Froderick 33 Fed Com 713H (FKA 503H) API #: 30-025-51733 EOG respectfully requests an amendment to our approved APD for this well to reflect the following changes:

**Froderick 33 Fed Com 713H****Revised Permit Information 04/27/2023:**

Revised Wellbore

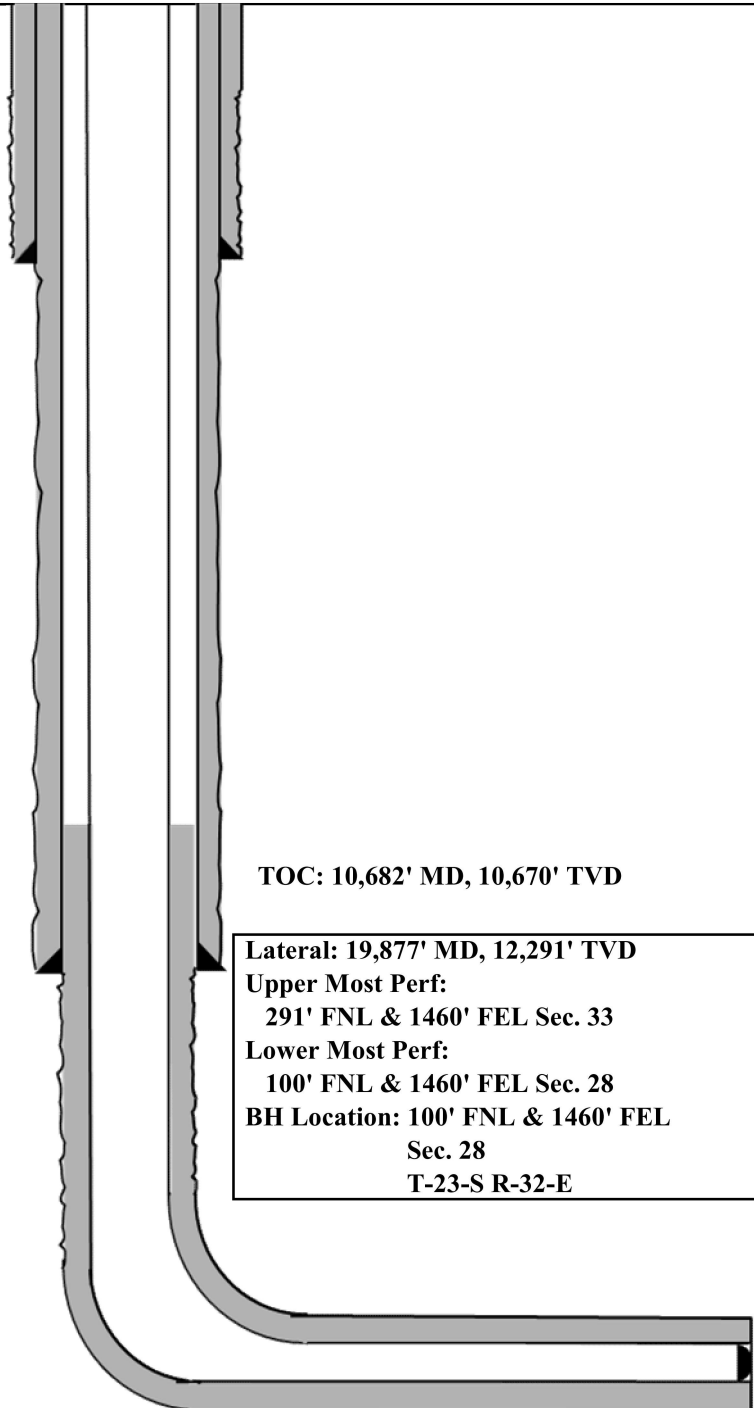
Update casing and cement program to current design.

Bit Size: 12-1/4"
9-5/8", 36#, J-55, LTC,
@ 0' - 1,260'

Bit Size: 8-3/4"
7-5/8", 29.7#, HCP-110, FXL,
@ 0' - 11,182'

Bit Size: 6-3/4"
5-1/2", 20#, P110-EC, DWC/C IS MS,
@ 0' - 10,682'
5-1/2", 20#, P110-EC, Vam Sprint SF,
@ 10,682' - 11,182'
5-1/2", 20#, P110-EC, DWC/C IS MS,
@ 11,182' - 19,877'
